APPLICATION NO.	FILING DATE	FIRST NAMED INVENTOR	ATTORNEY DOCKET NO.	CONFIRMATION NO.
09/766,025	01/19/2001	William R. Voigt	1515.3001.001	7873

Office Action Summary

FINAL ACTION***Claim Rejections - 35 USC § 102***

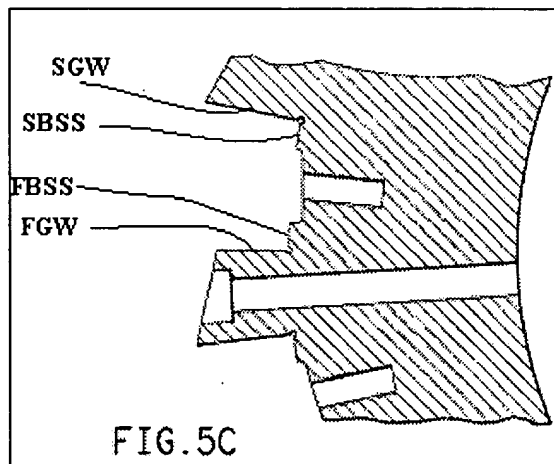
Regarding claims 1, 4 – 8 and 11 - 15, Samuels et al. discloses a polymer cutting apparatus of a helical nature (Col. 4, lines 24 – 26) comprising a rotor (7) having an outer surface, inherent left and right ends, a rotor axis (24) and inherent left and right end bearing supports concentric with the rotor axis. Samuels et al. further discloses a first groove wall (FGW, figure 5C by Examiner), in a first wall plane extending axially from the left end to the right end, extending outward away from the rotor axis and in the direction of rotation (see embodiment of figure 2), and wherein the first wall plane intersects the rotor axis. It is clear from figure 3 and 5A that the groove wall(s), if helically disposed as Samuels et al. discloses (Col. 4, lines 24 – 26), would intersect the rotor

axis (24). Samuels et al. discloses a plurality of first base support surfaces (FBSS, again in figure 5C by Examiner) that are in a first base support plane that is perpendicular to the first wall plane and wherein all the base support planes that are perpendicular to the first groove wall intersect each other. Furthermore, Samuels et al. discloses a plurality of first rectangular flat cutter blades (2, used by Samuels et al. to represent first and second cutter blades), each of which has a left blade end, a right blade end, a cutting edge and a base that is parallel to the cutting edge and wherein the base of each of the plurality of the first rectangular cutter blades is seated on one of the plurality of first base support surfaces (see figures 1, 3 and 5C).

Samuels et al. further discloses a second groove wall (SGW, figure 5C by Examiner), in a second wall plane extending axially from the left end to the right end, extending outward away from the rotor axis and in the direction of rotation (see embodiment of figure 2), and wherein the second wall plane intersects the rotor axis. It is clear from figure 3 and 5A that the groove wall(s), if helically disposed as Samuels et al. discloses (Col. 4, lines 24 – 26), would intersect the rotor axis (24). Samuels et al. discloses a plurality of second base support surfaces (SBSS, again in figure 5C by Examiner) that are in a second base support plane that is perpendicular to the second wall plane and wherein all the base support planes that are perpendicular to the second groove wall intersect each other. Furthermore, Samuels et al. discloses a plurality of second rectangular flat cutter blades (2, used by Samuels et al. to represent first and second cutter blades), each of which has a left blade end, a right blade end, a cutting edge and a base that is parallel to the cutting edge and wherein the base of each of the plurality of the second rectangular cutter blades is seated on one of the plurality of first base support surfaces (see figures 1, 3 and 5C).

Regarding claim 3, Samuels et al. discloses all of the elements as set forth in the above rejections including the disclosure of a first leading groove wall (FGW- figure 5C).

Applicant first argues that Samuel et al. fails to disclose a rotary cutter with a helix angle and with walls and planes arranged in the manner disclosed in claim 1. The Examiner has considered Applicant's arguments and found them not to be persuasive. Please refer to figure 5c previously provided by the Examiner. The elements of claims 1, 3 – 8 and 12 – 15 are clearly anticipated by Samuel et al. The first groove wall (FGW) is perpendicular to the first base support surface (FBSS). Every other element of claim 1 is disclosed by Samuel et al. including the clamping arrangement.

al. discloses exactly this limitation. Comparing figure 5c of Samuels et al. to the instant invention it is the determination of the Examiner that the inventions are substantially identical regarding the argued limitations.

Regarding claims 12 – 14, Applicant argues the same structure set forth in the above rejections regarding the base support surfaces and groove walls and again claims that no two first wall planes are parallel to each other. The Examiner still relies upon Samuels et al. and closely inspects figures 5b and 5c. It is clear that adjacent grooves possess first wall planes that are not parallel to each other. The Examiner does not understand Applicant's arguments regarding the number of knives utilized nor the replacement of said knives since no such limitation is gleaned by claim 12.

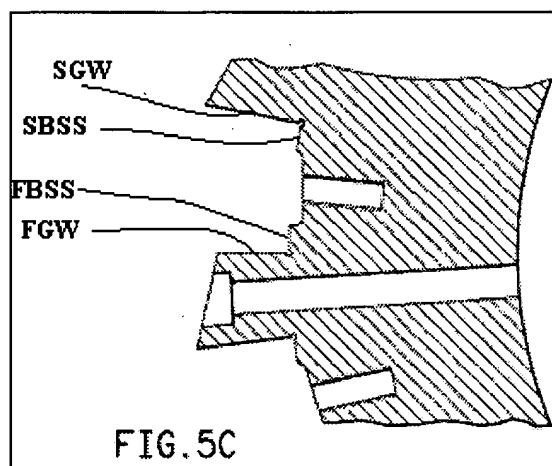
It would have been obvious to one having ordinary skill in the art at the time the invention was made to modify the number of support surfaces in the apparatus disclosed by Samuels et al. since it has been held that mere duplication of the essential working parts of a device involves only routine skill in the art. *St. Regis Paper Co. v. Bemis Co.*, 193 USPQ 8. Furthermore, Applicant has provided no evidence that the use of exactly four first and second base support surfaces in the apparatus is critical to the workability of the device.
